EXISTING FACILITY PRELIMINARY ASSESSMENT REPORT

Waterside at Flathead Lake Condominiums
7175 U.S. 93 South
Lakeside, Montana 59922

Report Date: October 16, 2023

Reported By: Studio Obermeier Sheykhnet Architecture
New Rome Engineering et. Al.

SKA- 631

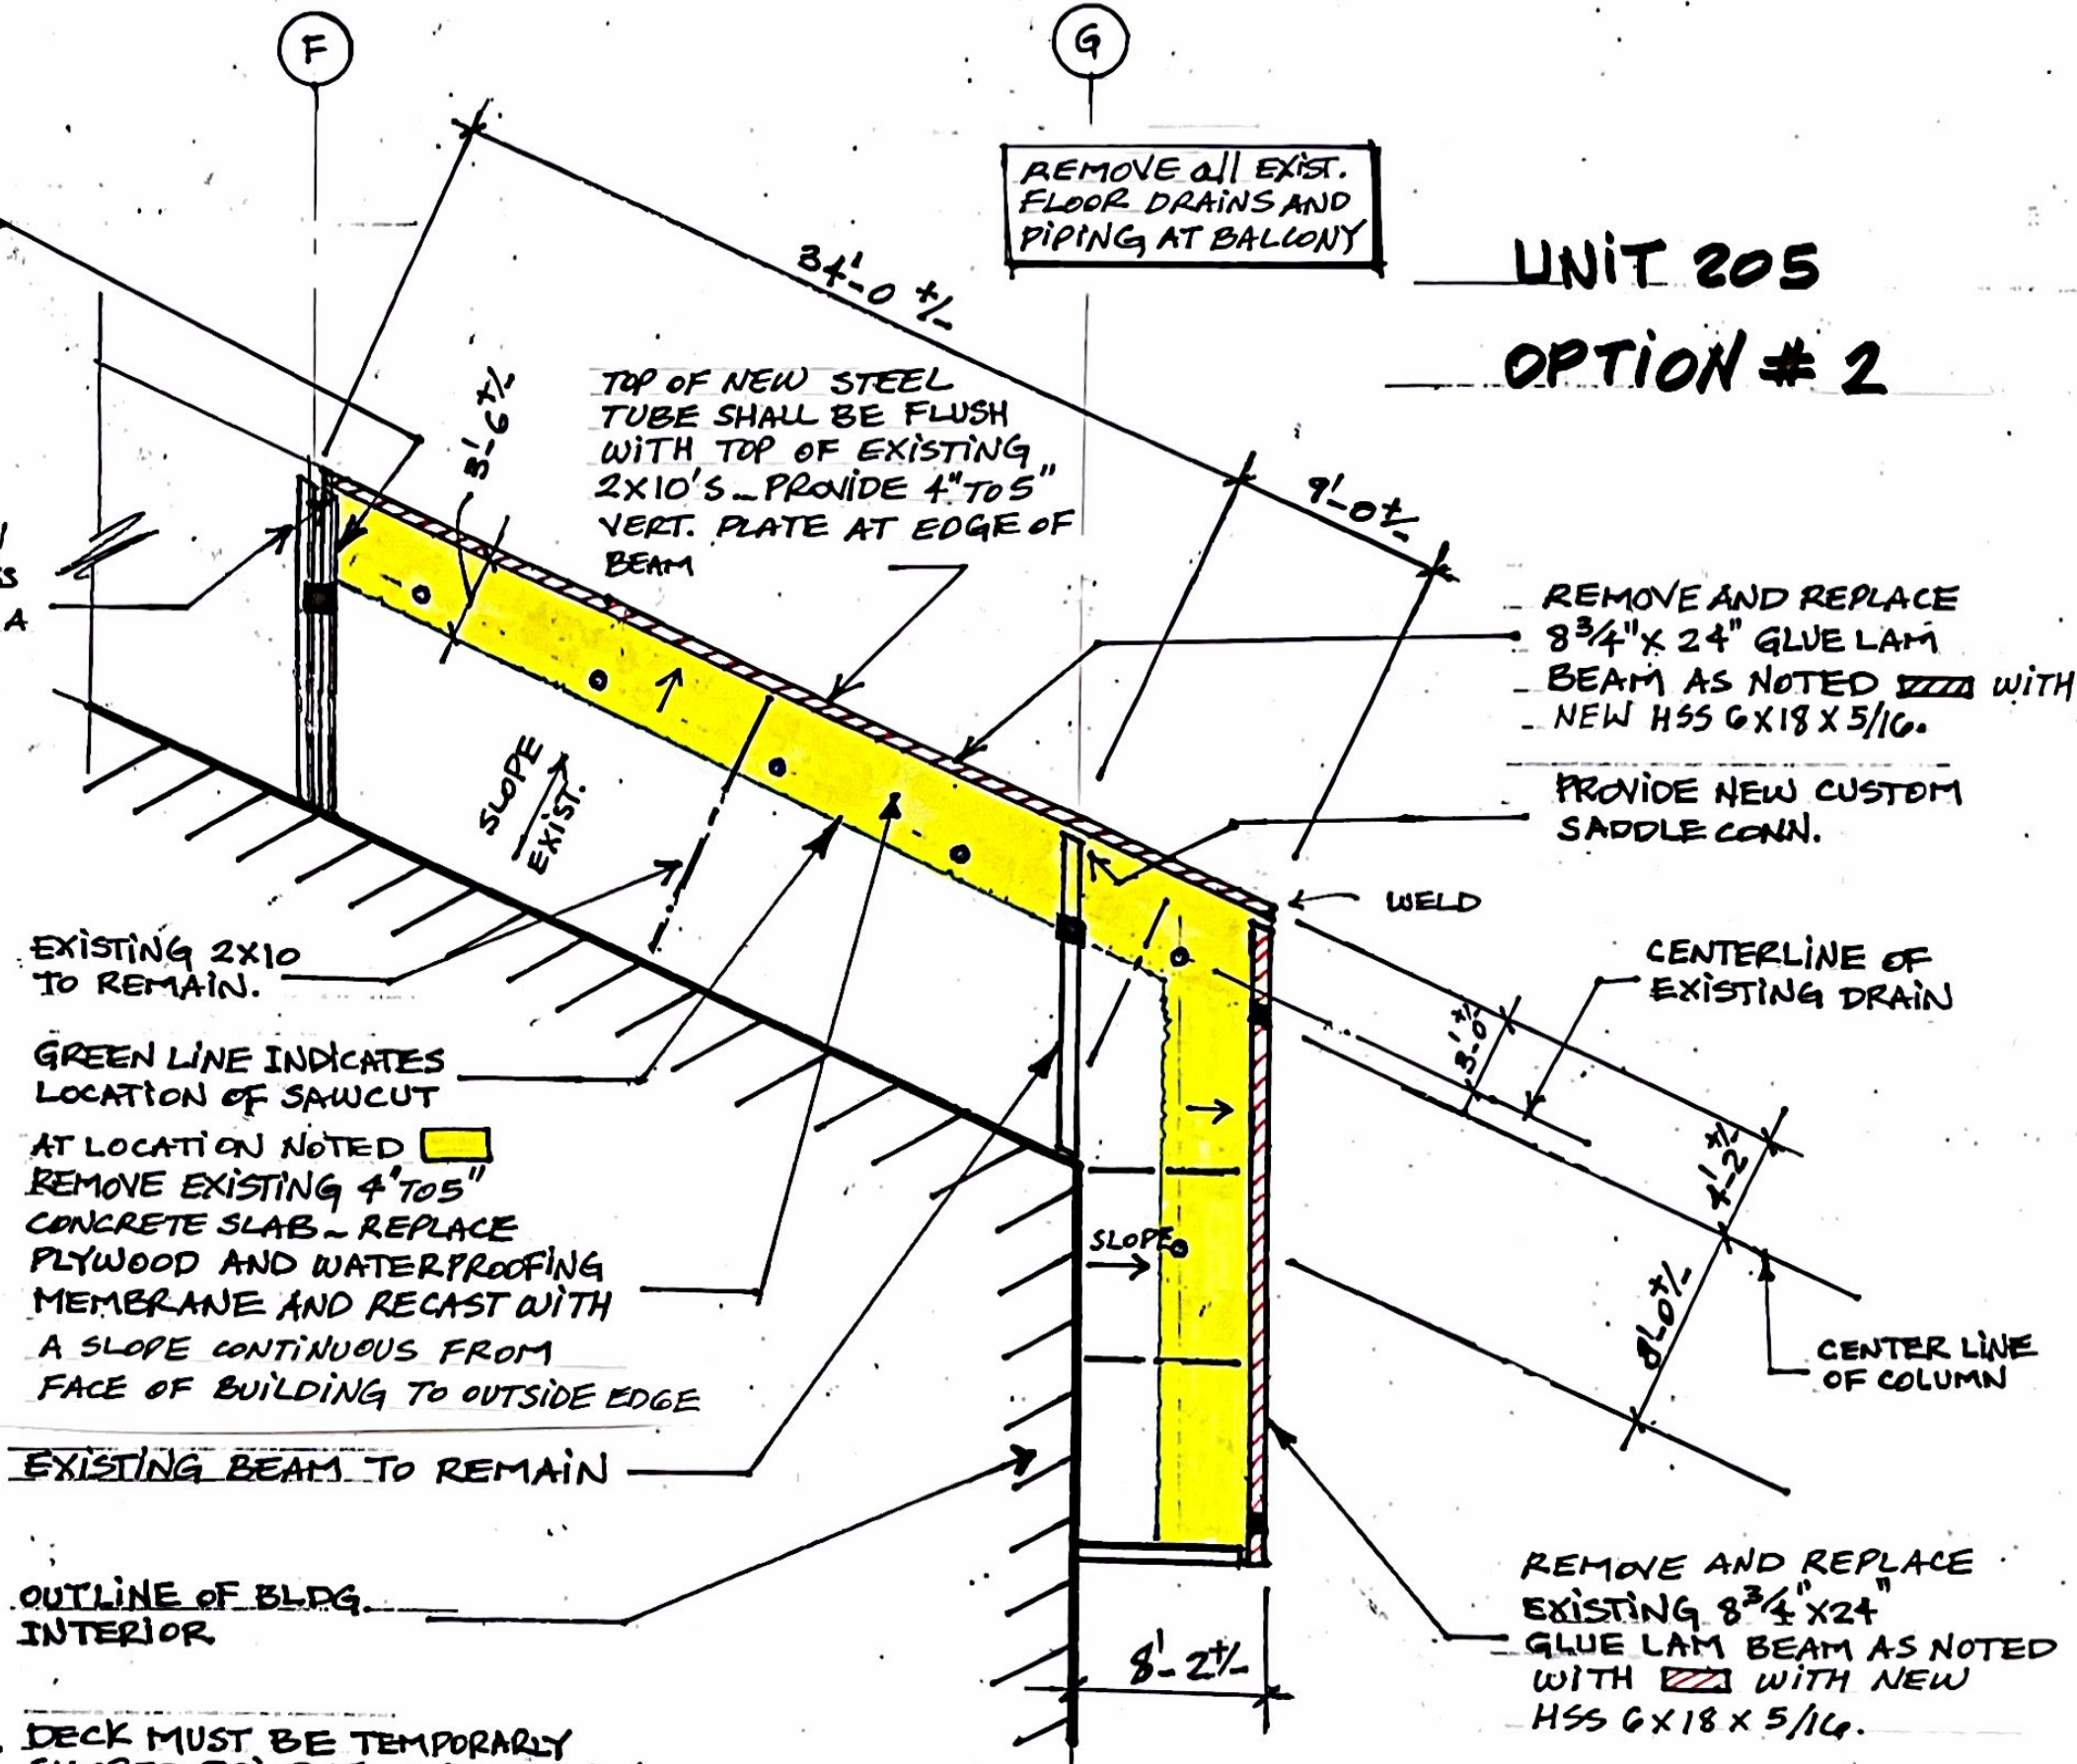
CUT END OF EXISTING 5 1/4" X 30" ROUGH SAWN AND RECONNECT 8 3/4" X 24" GLUE LAM WITH A NEW METAL SADDLE AS SHOWN BELOW

REMOVE EXISTING 4" TO 5" CONCRETE SLAB - REPLACE PLYWOOD AND WATERPROOFING MEMBRANE AND RECAST WITH ADEQUATE SLOPE - AS NOTED WITH

REMOVE AND REPLACE 8 3/4" X 24" GLUE LAM BEAM AS NOTED

- a. Perimeter beam
 - i. Replace existing glulam beam with new wood glulam beam in kind, same size and profile.
- b. Outrigger support beams
 - i. Trim end of rough sawn outrigger beam and connect new perimeter beam with a new metal saddle bracket.

- c. Balcony deck
 - i. Cut and remove 4-5 feet section of concrete deck along entire perimeter edge of the balcony.
 - ii. Replace damaged and/or rotted plywood deck.

- iii. Install new waterproof membrane. Provide proper overlap and splicing with existing membrane.
 - iv. Rework all flashing.
 - v. Recast concrete with adequate slope to drains. 1/4" per foot minimum slope.
